IN THE MATTER of an application for resource consent under section 88
of the Act for the establishment and operation of a sand
quarry and cleanfill operation located at 928 Kaipaki
Road, Cambridge

**SUPPLEMENTARY STATEMENT OF EVIDENCE OF ALASTAIR JAMES BLACK FOR
THE APPLICANT**

(Traffic)

Dated: 23 November 2020

Figure 1: Walkers Paddock Gate, Google Streetview, December 2019

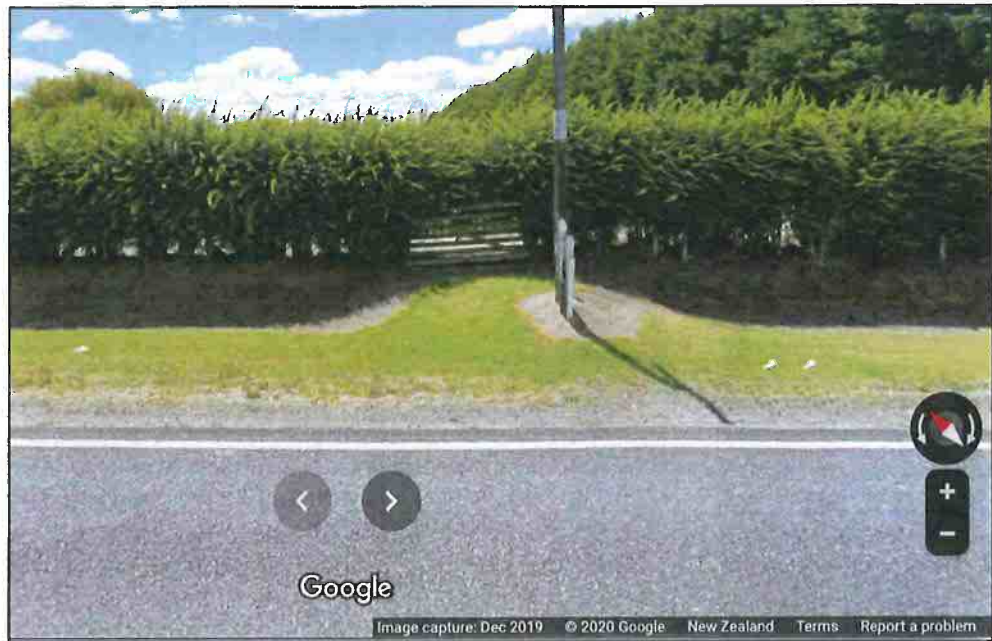
14. Mr Apeldoorn raises concerns about how the existing paddock gate will continue to be accessed. It is unclear from the Walker's initial submission, their statement of submitter and Mr Apeldoorn's evidence how often the gate is used and by what mode (e.g. vehicles, pedestrians, or horses). The existing paddock gate is 3m wide and setback approximately 8m from the edge line. The location of the existing power pole restricts the ability of the gate to be used by vehicles.

15. I have reviewed Google Streetview and the image at Figure 1 clearly demonstrates that the paddock gate was unable to be used in December 2019 due to growth of the hedge.

17. Mr Apeldoorn's suggested condition would allow a non-compliant access to be retained to the Walker's property. As discussed the frequency and nature of use is unclear, and the Google Streetview image illustrates that the gate may not be used for long periods of time. It is unclear what authorisation or approval established this paddock gate. I do not support Mr Apeldoorn's proposed condition as it would retain a non-complying access to a minor arterial.
